Department of Health
 Bureau of Environmental Health
 3 Harry S. Truman Parkway
 Annapolis, MD 21401
 Phone 410-222-7193 www.aahealth.org
 Fax 410-222-7479

RE: Perc #T02044353
 Tax Account #388600003550
 Site: 7642 LAKE DRIVE
 PASADENA

DEPARTMENT OF HEALTH
PERC DATA FORM

SOIL TEST/SITE EVALUATION

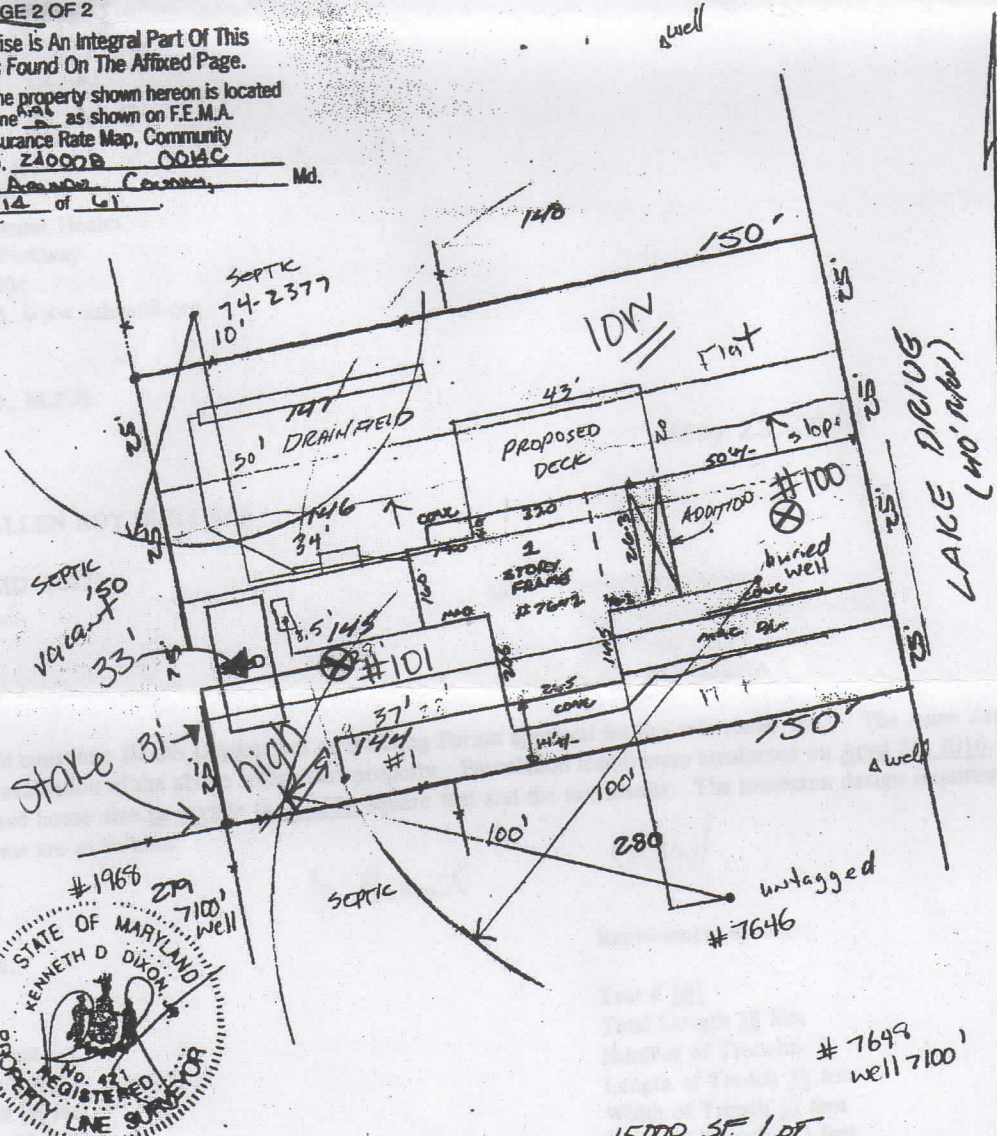
#1, #101
 $(4.5)(30)(3) = 459$
12' x 38' PDB

Lot is now vacant
BAT req
May not have room for initial & 2 replacements
